**ENGINE SYSTEMS, INC.**175 Freight Road  
Rocky Mount, NC 27804Telephone: 252/977-2720  
Fax: 252/446-1134**TELEFAX**

**Report No. 10CFR21-0136**

**10CFR21 REPORTING OF DEFECTS  
AND NON-COMPLIANCE**

COMPONENT: Voltage Regulator Chassis – Incorrect Bus Bar Installation  
P/Ns: 72-12300-100-ESI  
72-14200-100-ESI  
72-14000-100-6020

Photo 1: Incorrectly Installed Bus Bar

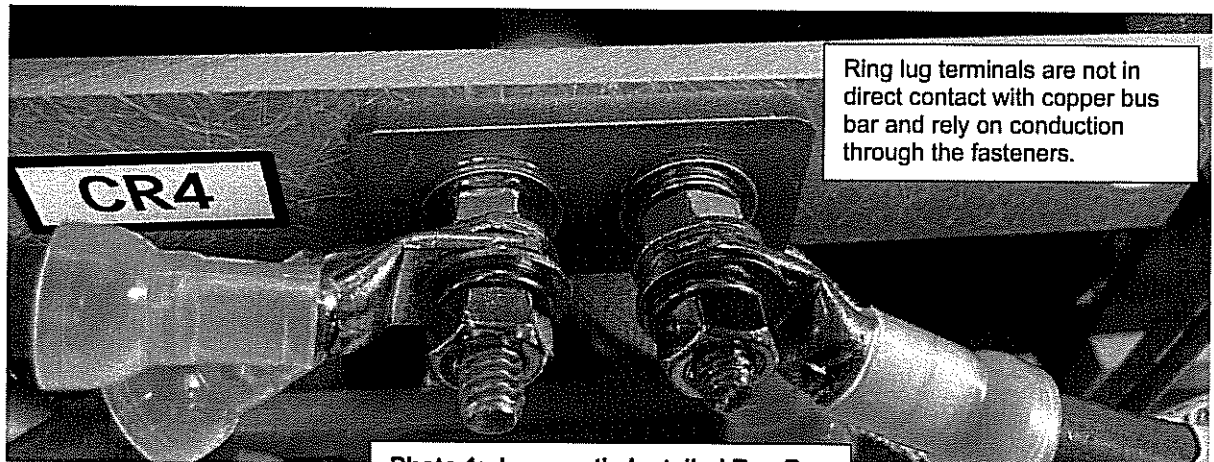
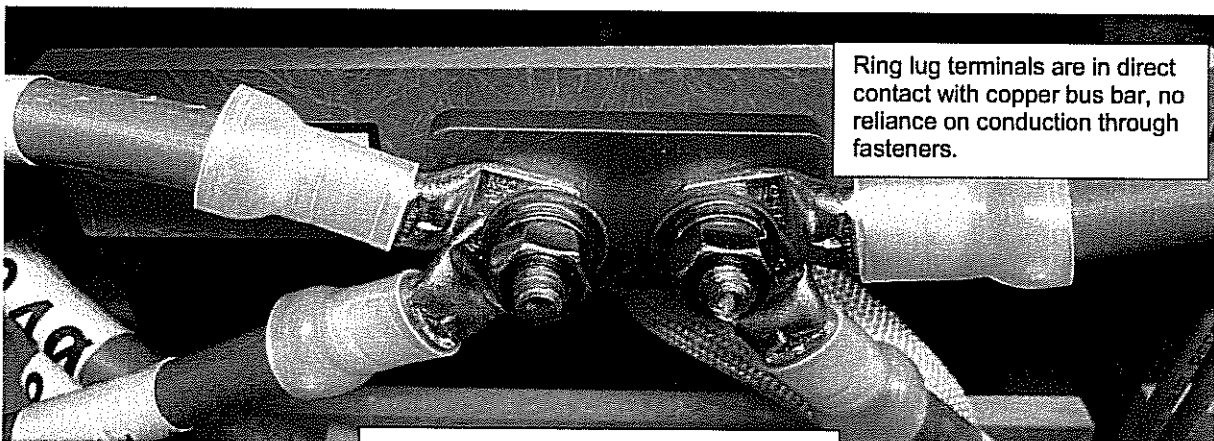
*Copper bus bars are used at rectifier diode pigtail connections CR1, CR2, CR3, CR4, and CR7 to provide a common connection point for associated wiring to minimize the number of conductors on a single fastener. It is intended for the conductors to clamp directly to the bus bar, thereby maintaining a low resistance conduction path between components. ESI has determined the bus bars were installed incorrectly whereby the conductors are not clamped in direct contact, resulting in current flow through the stainless steel fasteners. This configuration is undesired and will result in unnecessary heat generation which may lead to failure of the connection and therefore failure of the automatic voltage regulator (AVR) assembly. The AVR is relied upon to automatically regulate emergency diesel generator (EDG) terminal voltage. Failure of the AVR would impact ability of the EDG to perform its safety-related function and therefore may impact the nuclear plant's ability to manage safety-related loads during an emergency event.*

*Photos below show an example of an incorrectly installed bus bar (photo 1) and one that is correctly installed that ensures proper conduction (photo 2). Photos and figures on the following pages provide additional information.*

*Bus bar installation should be corrected immediately by restacking the components to ensure direct contact with all conductors. See section viii below for details.*

**Figure 1: Cross Section - Incorrect Bus Bar Install**  
(Note bus bar is not in direct contact with wire lug and diode pigtail)

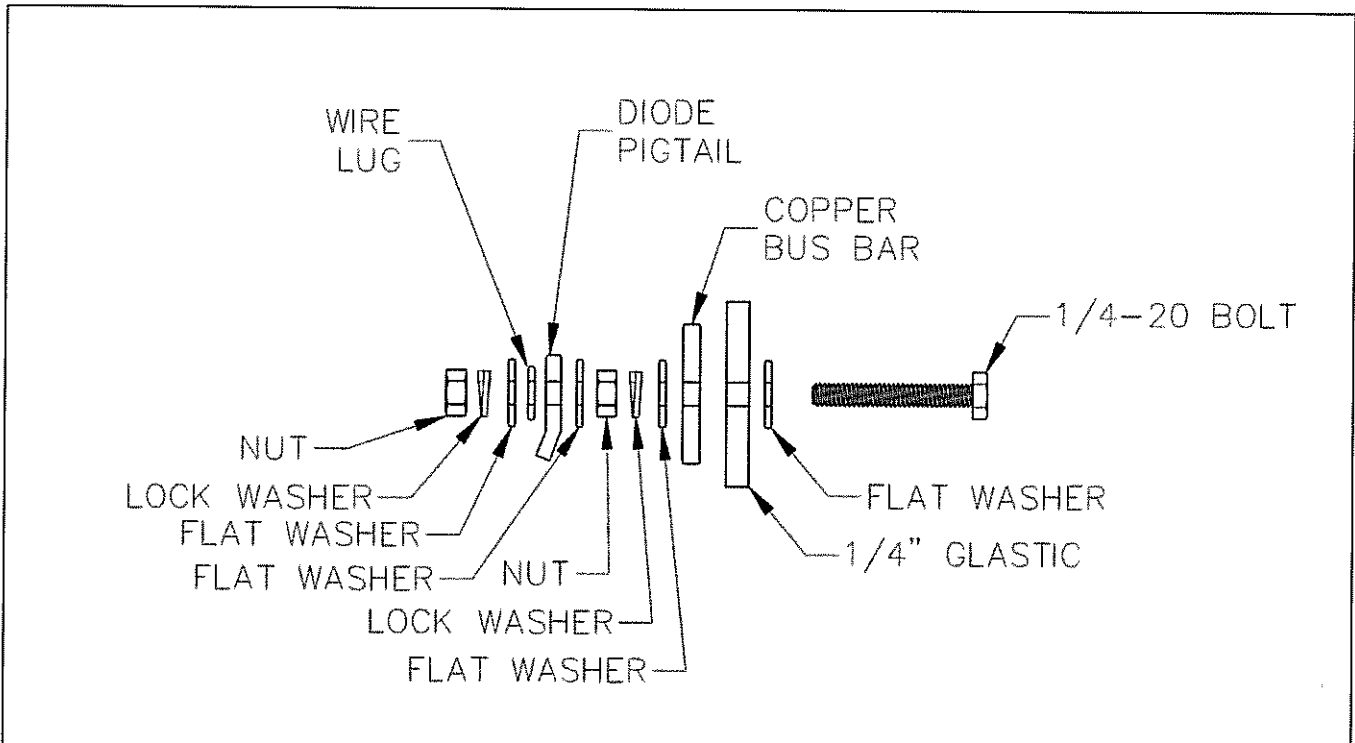
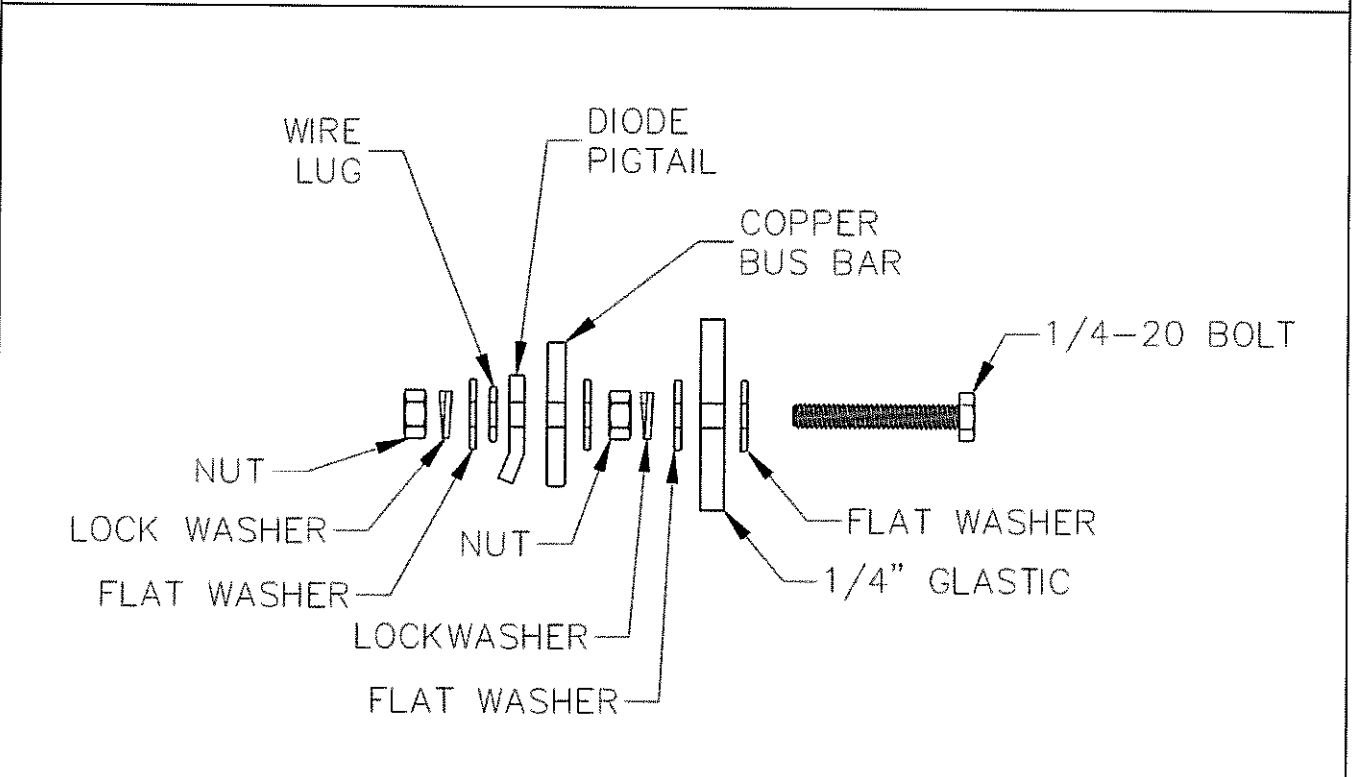
**Figure 2: Cross Section - Correct Bus Bar Install**  
(Note wire lug, diode pigtail, and bus bar stacked in direct contact)

Figure 3: Outline Drawing - Chassis Upper Half

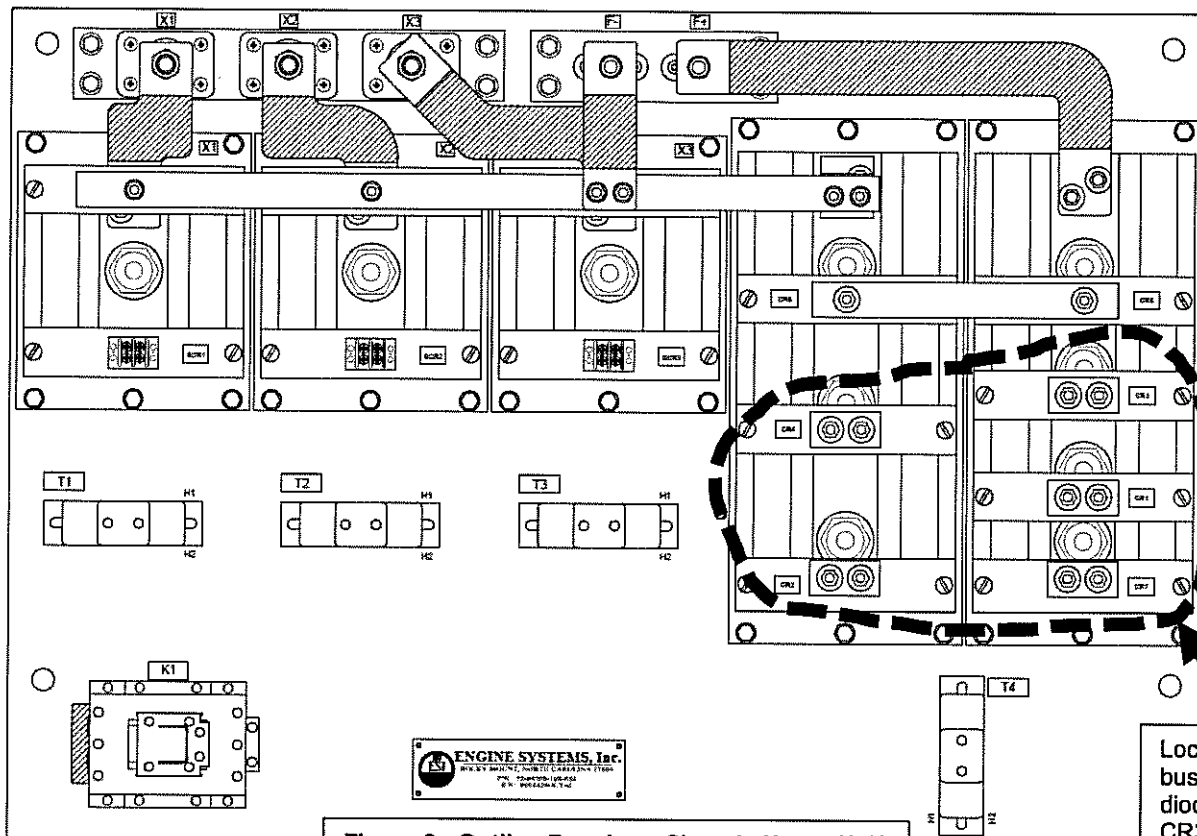
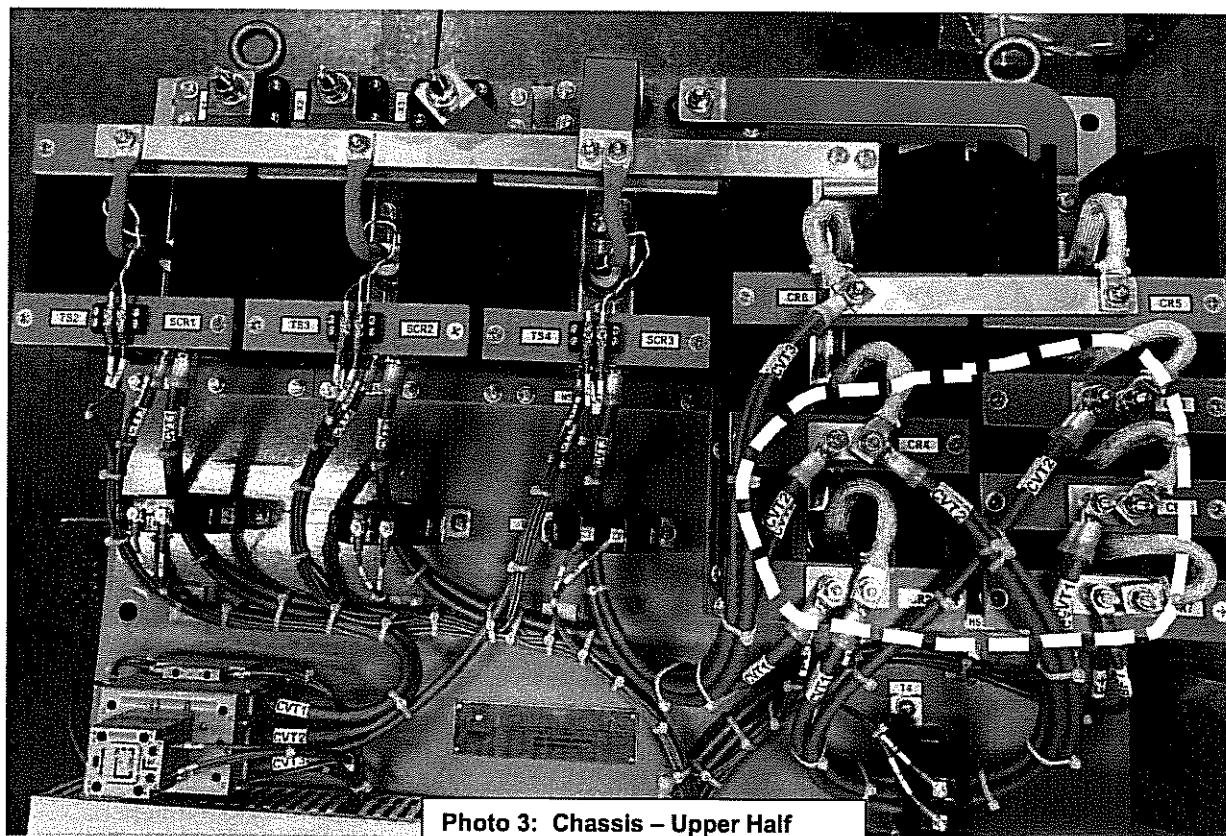
Figure 3 and photo 3 below show location of the bus bars on the voltage regulator chassis.

Location of the five bus bars at rectifier diodes CR1, CR2, CR3, CR4, & CR7
